WELWYN HATFIELD D.C.
RECEIVED 20 MAR 1992
S6/202/92

PROPOSED EXTERNAL ESCAPE STAIRCASE
44 FORE STREET
HATFIELD
for
Mr. & Mrs. D. SHIRLEY

PLANNING DRAWING

PROPOSED REAR ELEVATION

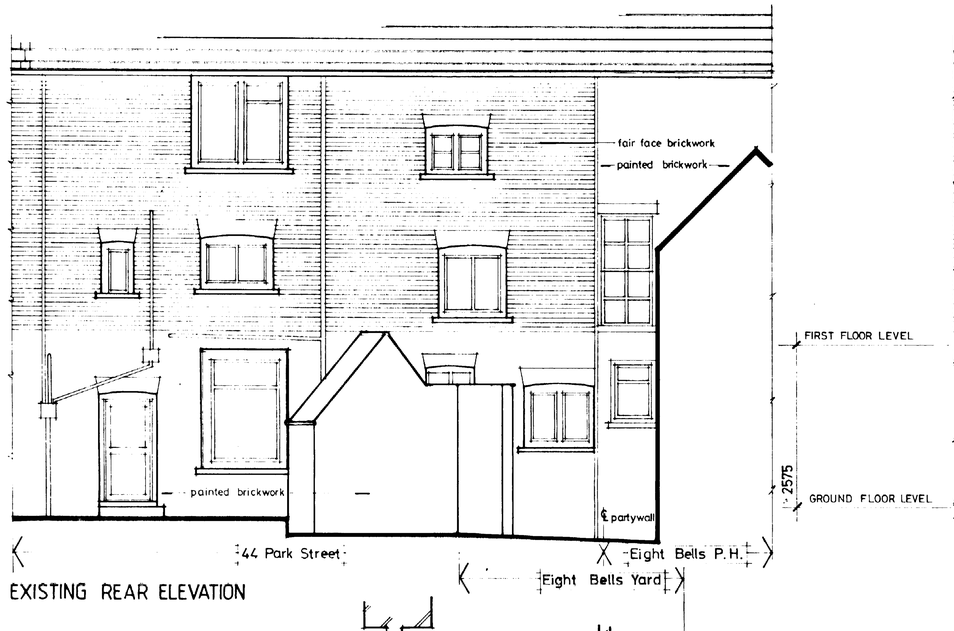
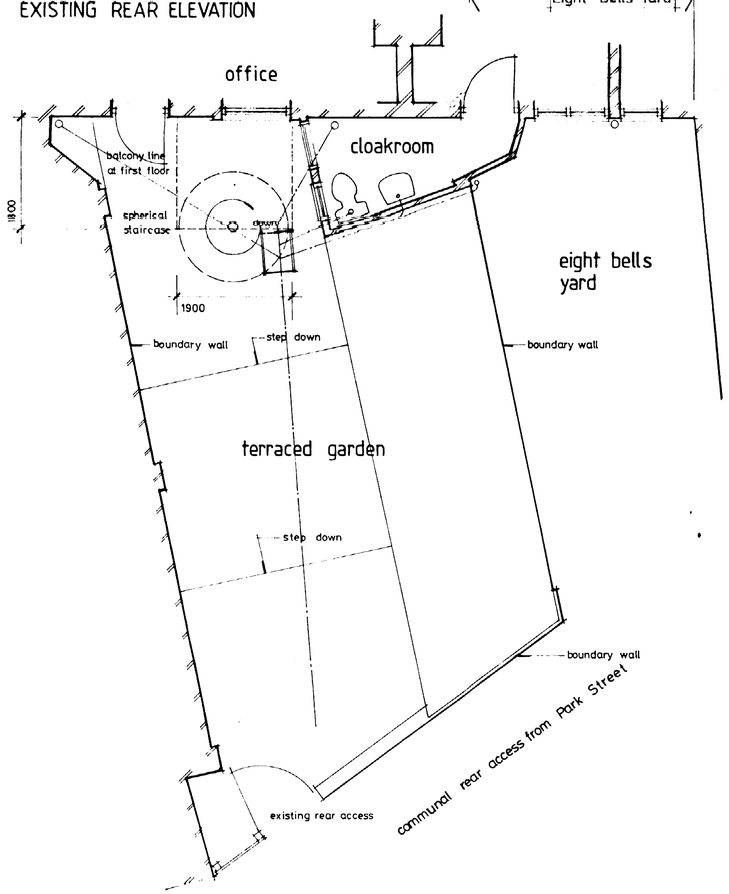
Amendment 1.
First Floor external escape landing projection increased to 1800 to increase staircase clearance from Ground Floor window.
Double doors opening out in lieu of single door at First Floor level. March 1992
FH.
